UNITED STATES PATENT AND TRADEMARK OFFICE

Office Action Summary	Application No. 10/816,784	Applicant(s) THOMPSON ET AL.	
	Examiner SUBA GANESAN	Art Unit 3774

DETAILED ACTION

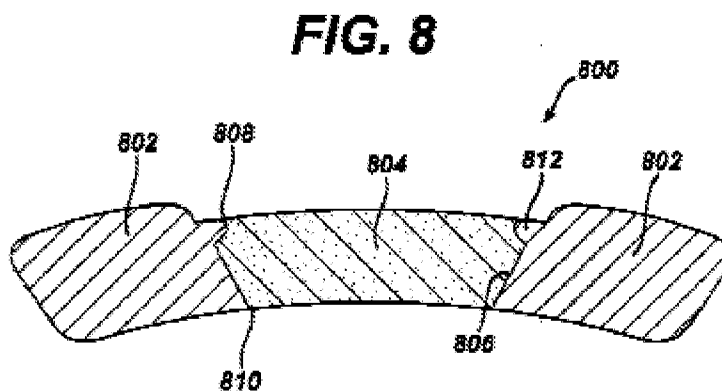
5. Claim 24 is rejected under 35 U.S.C. 102(b) as being anticipated by Bonsignore et al. (U.S. P.G. Pub. No.: 2004/0186555).

6. Bonsignore discloses a stent with a main body and flared end struts. The end struts of Bonsignore define radial thinning along their lengths (see fig. 8 below) in both the collapsed and expanded configuration.
